Model HW 102

TECHNICAL INFORMATION

2012/43

Subject	Outlet pump kit
For model	HW102
Country	Worldwide
Description	The pump outlet has been changed to a new system. If repair is needed, the pump outlet has optionally to be converting to the new pump repair kit.

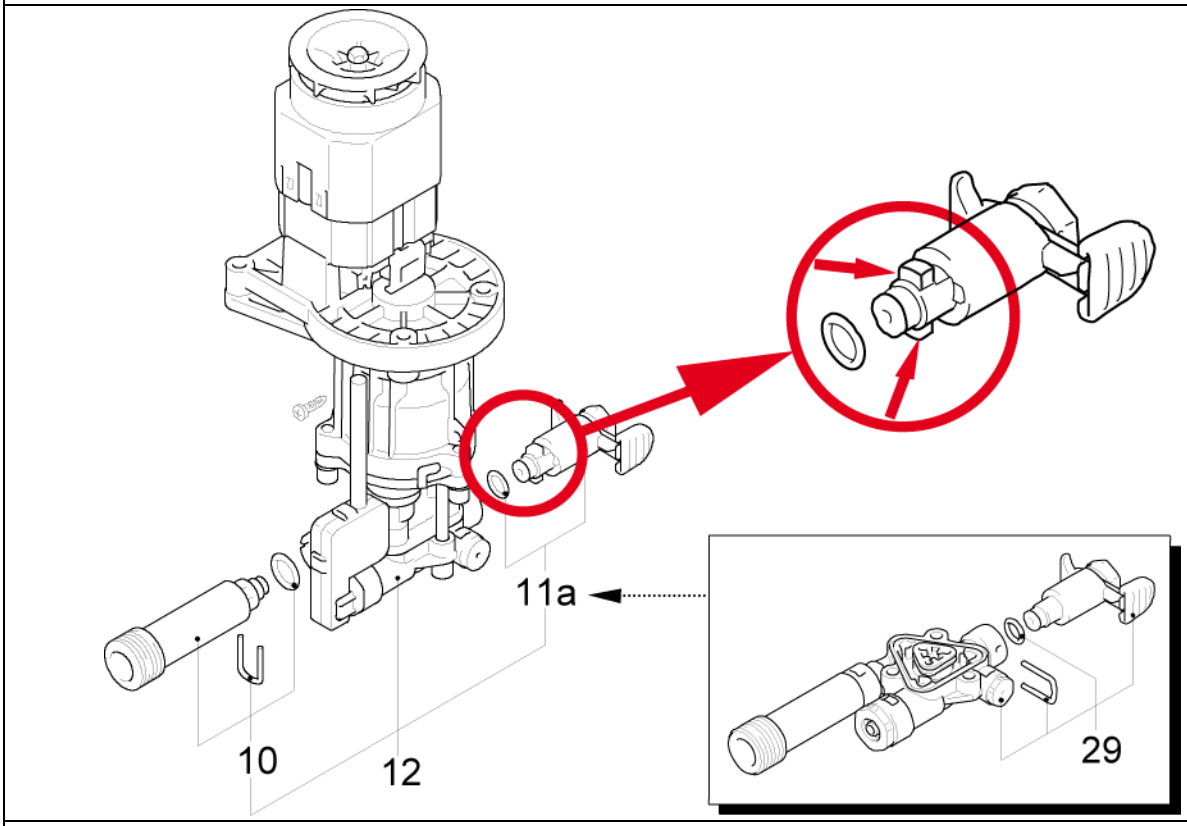
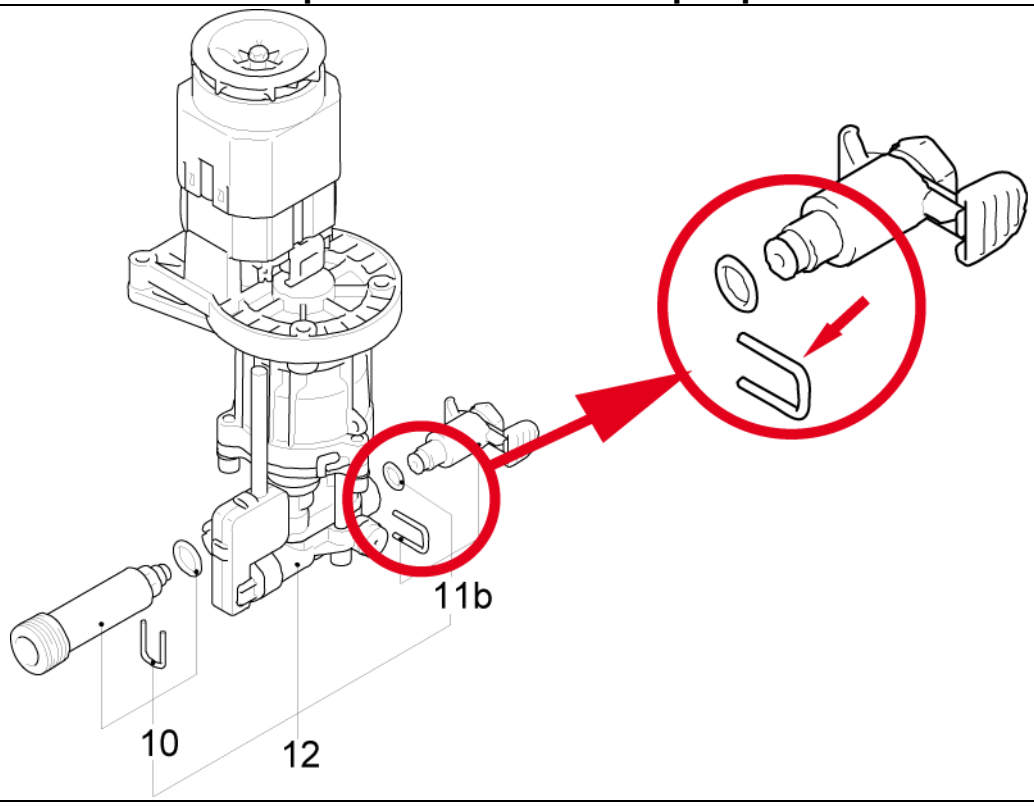
Old Version: The pump outlet is used with a bayonet connection to the pump

New Version: Pump outlet is hold in position with a clamp

Pos. No.	Q'ty	Old part	Description	I/C	Pos. No.	Q'ty	New part	Description
11a	1	364 0590	Outlet pump kit	Yes ←	29	1	42 734	Pump repair kit

If the outlet pump kit 364 0590 is discontinued, the pump repair kit 42 734 has to be used.

Pos No.	Part number	Q´ty	Description
11b	364 1651	1	Outlet pump kit
